ENGINE FUEL FEED LINE

<u>MODEL</u>	<u>S/N</u>
750XL	101 thru 215, 220
750XL	8001, 8002

During a review of the installation of the Powerplant Fuel Lines and Electrical Installations (forward of the Engine Firewall), it was found that the Engine Fuel Feed Line and Fuel Pressure Transducers could potentially chafe against adjacent Electrical Wiring and the Ignition Exciter.

FIGURE 1 INSPECTION AREA – L.H.S OF POWERPLANT

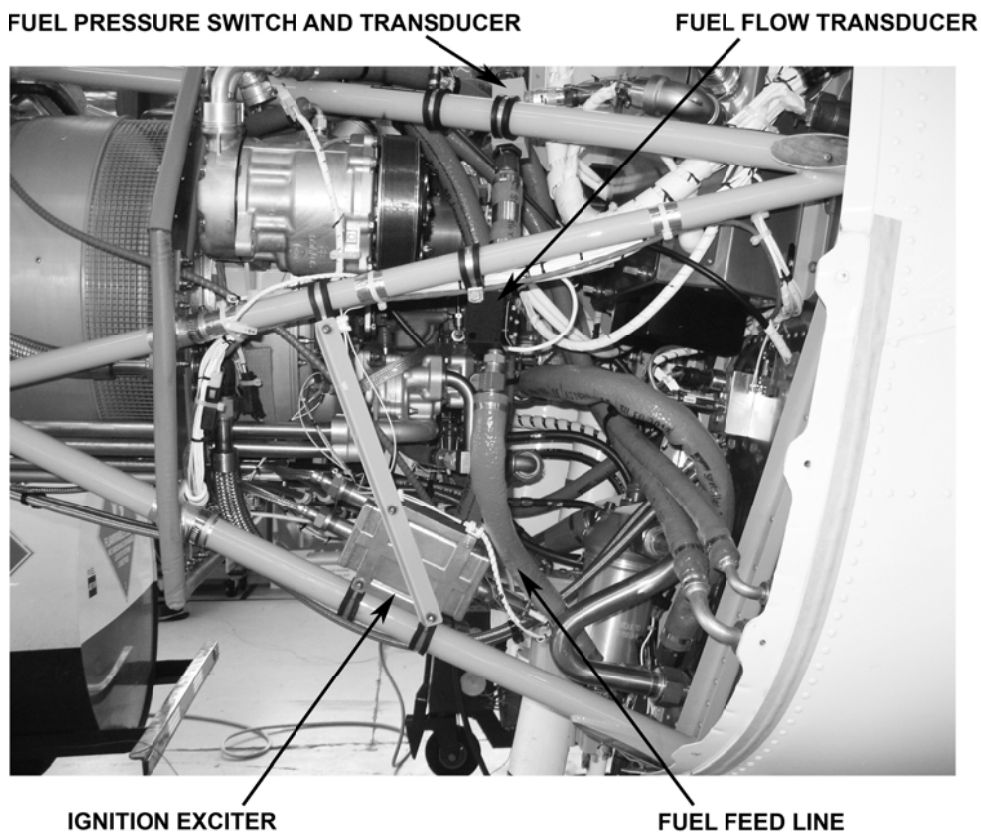
- 1) Initial inspection may be carried out in conjunction with the normal 150 hour inspection procedures detailed in the Approved Maintenance Manual.
- 2) If the Engine Fuel Feed line and Ignition Exciter are installed in the configuration shown in Figure 1 below, then carry out inspection detailed below.

- 3) Inspect the Fuel Feed Line hoses from the Firewall to the Oil/Fuel Heater for signs of chafing, paying particular attention to the areas adjacent to the Ignition Exciter and Connector and the Battery Power Cable.
- 4) Inspect the Electrical Wiring Loom adjacent to the Fuel Pressure Switch and Transducer Connectors and along the Engine Mount Tubing for signs of chafing.
- 5) If chafing is found which penetrates the (orange) outer covering of the Fuel Line Firesleeve or if chafing or damage is found to Electrical Wiring, corrective actions detailed in PART B are to be carried out before further flight.
- 6) If no chafing is found, corrective actions are to be carried out in accordance with Part B within 300 hours.

FIGURE 2 RELOCATED HOSES – L.H.S. OF POWERPLANT

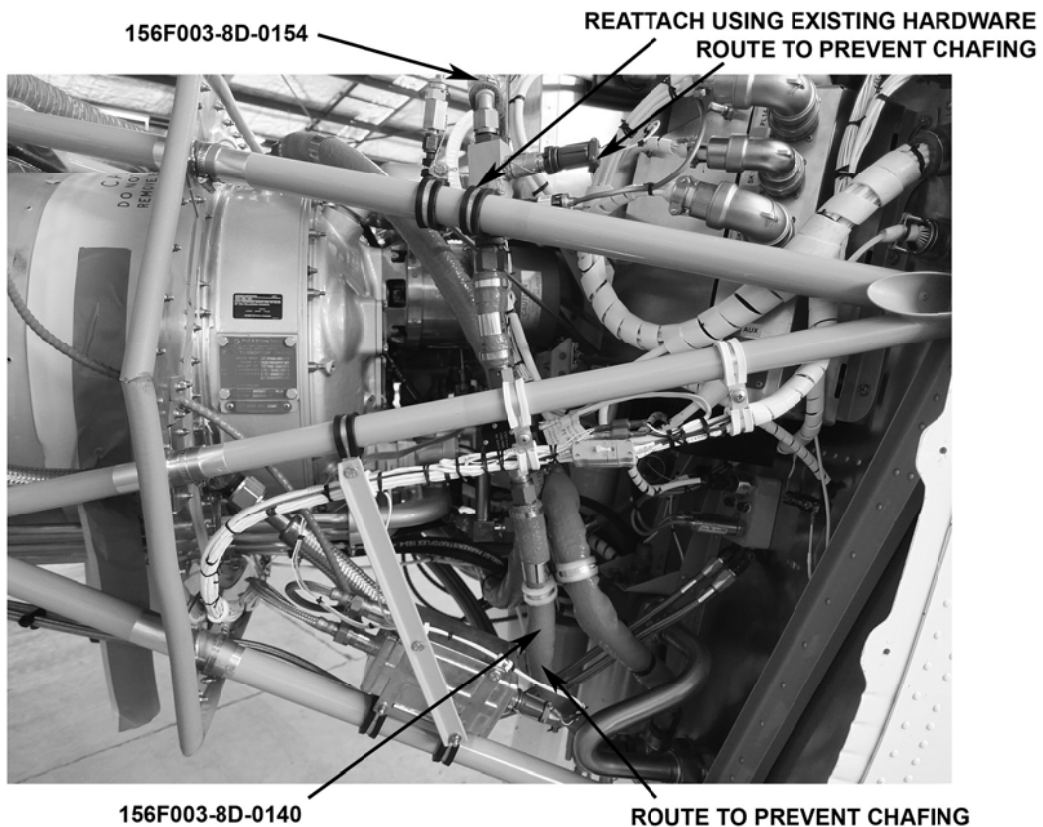
- 4) Reinstall the (longer) P/N 156F003-8D-0154 Hose to run from the Pressure Switch/Transducer Manifold to the engine. Reinstall the (shorter) P/N 156F003-8D-0140 Hose to run from the Firewall Tee to the Fuel Flow Transducer inlet. Reinstall the Fuel Flow Transducer and the Fuel Pressure Switch/Transducer Manifold. Refer to Figure 2 and Figure 3 below.

FIGURE 3 RELOCATED HOSES – L.H.S. OF POWERPLANT

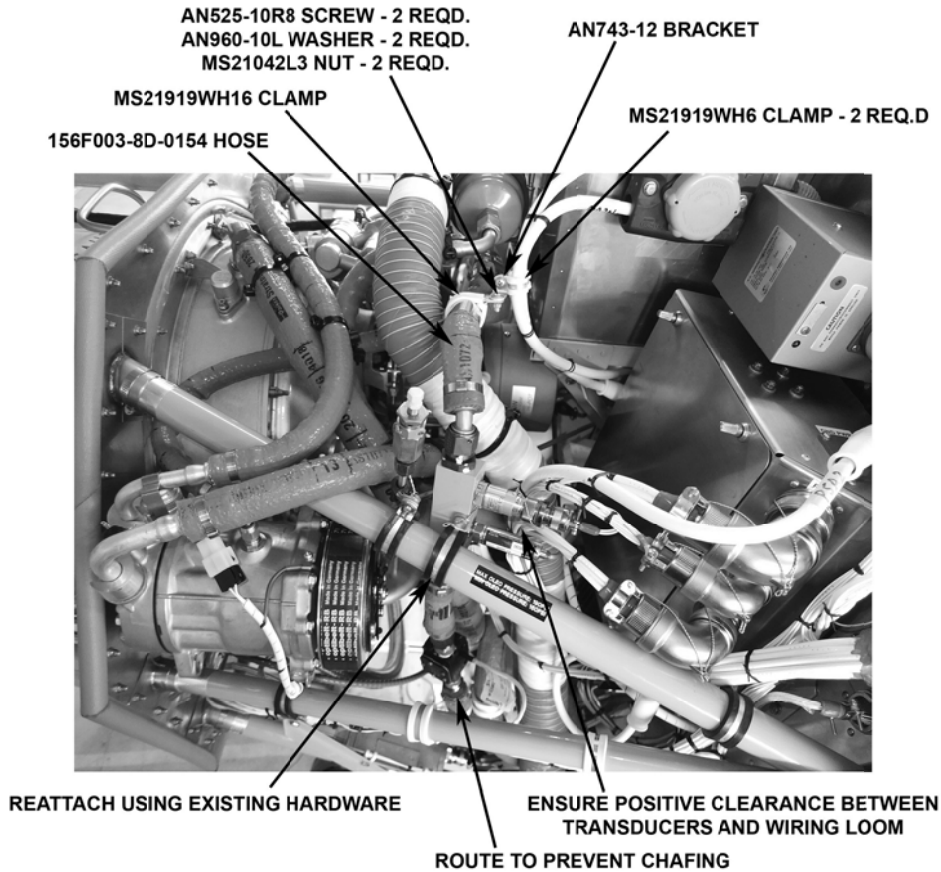
- 6) Ensure all Fuel Lines are routed to prevent chafing against adjacent components and electrical wiring prior to tightening the fittings and installing the P Clips. Ensure the Main Battery Leads are P-clipped to the Fuel Feed Hose to ensure positive separation (See Figure 3).

FIGURE 5 P CLIPPING OF ELECTRICAL LOOM

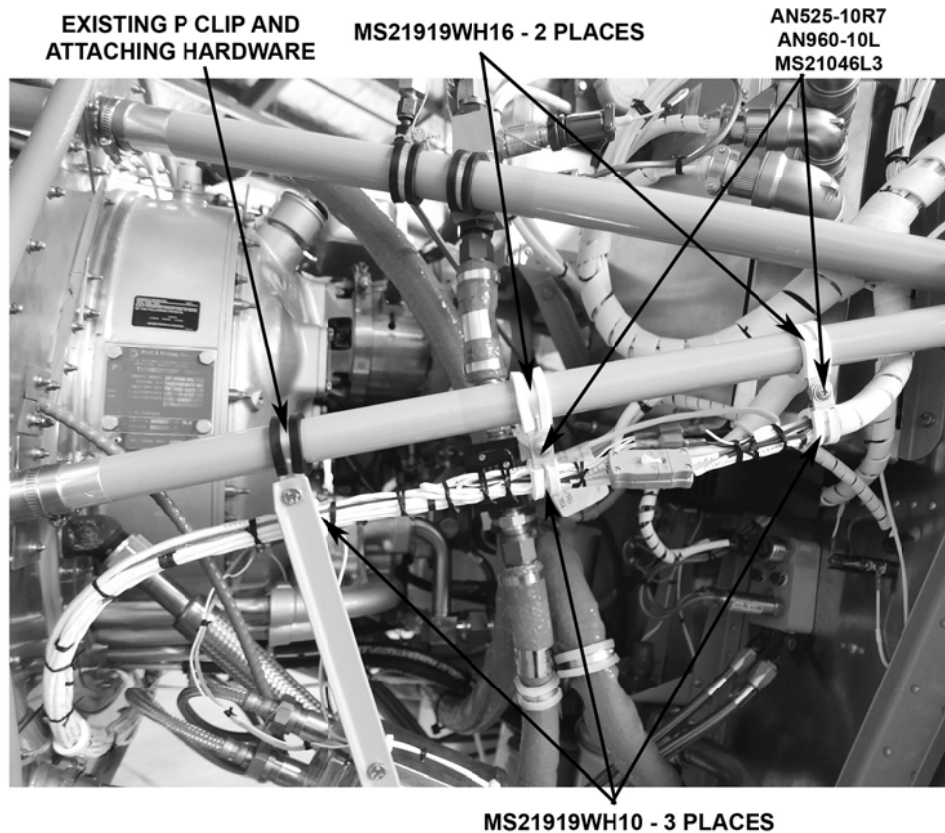
- 8) Remove Tyrapas attaching Electrical Loom to Engine Mount Truss (if fitted) and install P Clips (See Figure 5). Reroute Fuel Transducer and Pressure Switch Wiring to existing Main Looms and tie/secure as required I.A.W. AC43.13-1B Para 11-96.
